**Re: QuikTrip 7001, Albuquerque**  
**Matkin Hoover Job No. 7001.01**  
**DFT PRJ # PR-2024-011229**

This letter and its attachments serve as a response to comments received on Dec 16<sup>th</sup>, 2024, concerning the above reference project.

# QUIKTRIP STORE #7001

SHEET TITLE:  
 UTILITY PLAN SOUTH

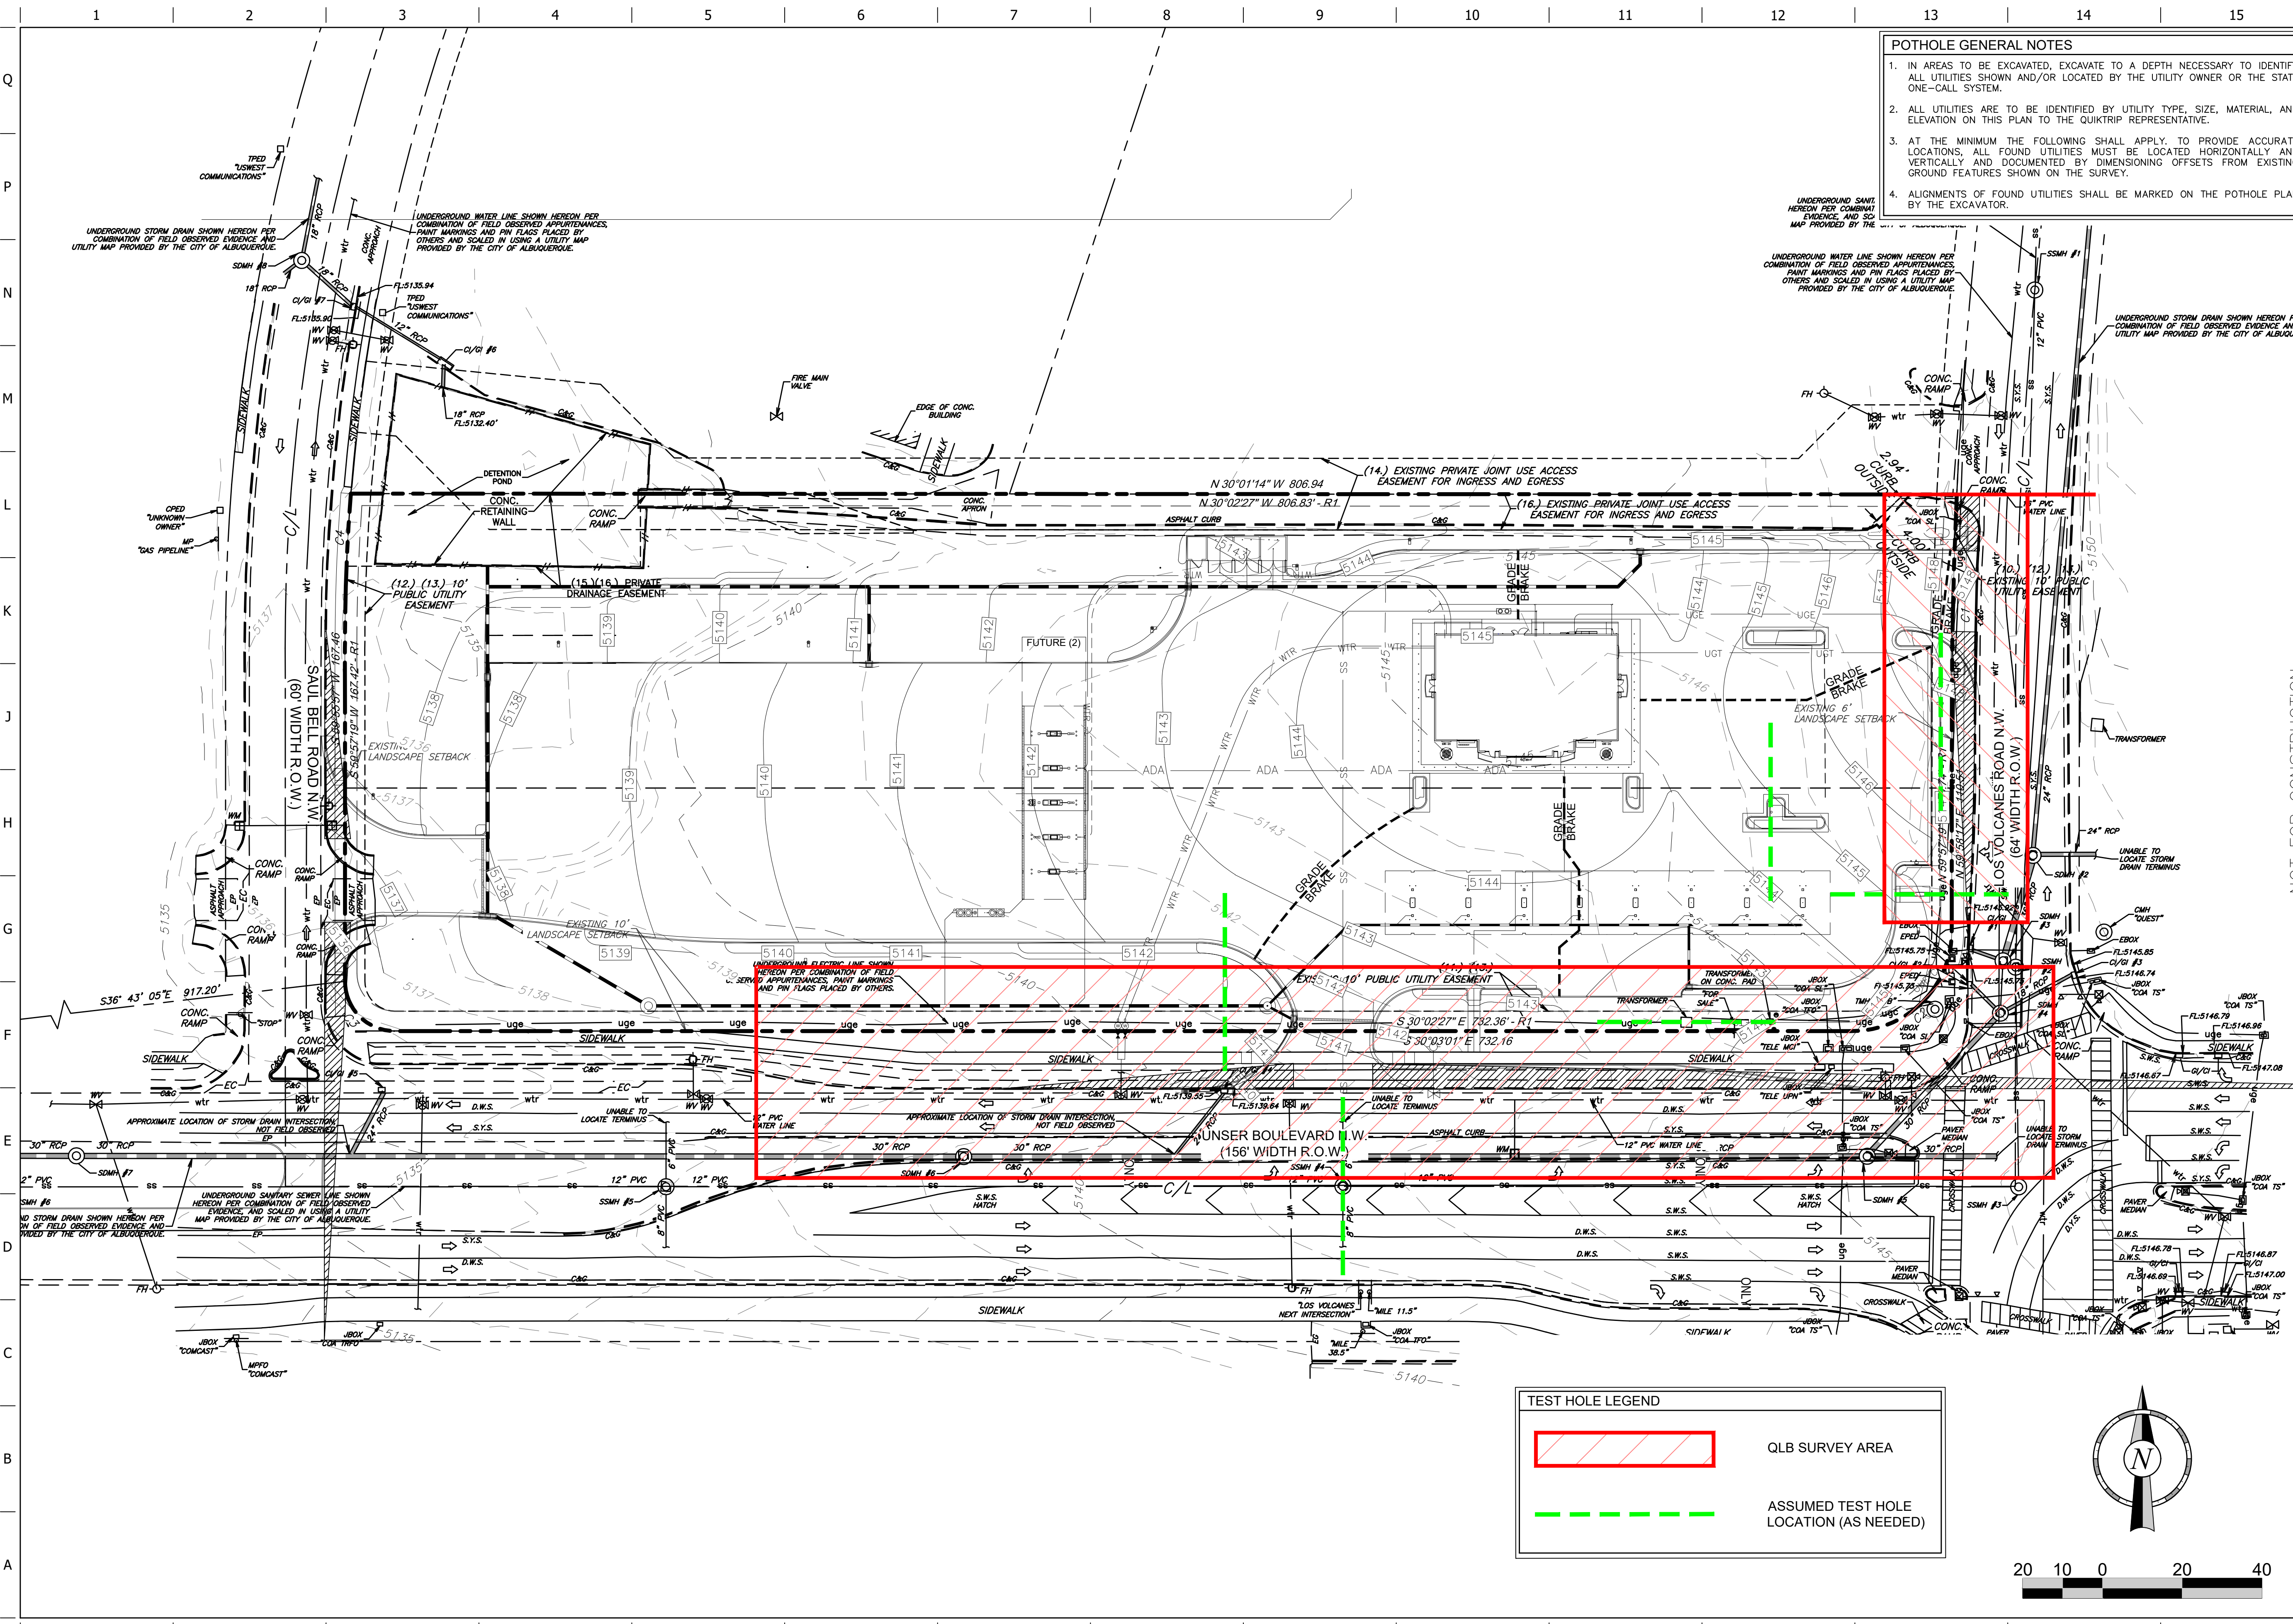
Dimension the public water and public sewer easements on the utility plan.

Concur. Utility Easement Callouts added to both north and south utility plans.
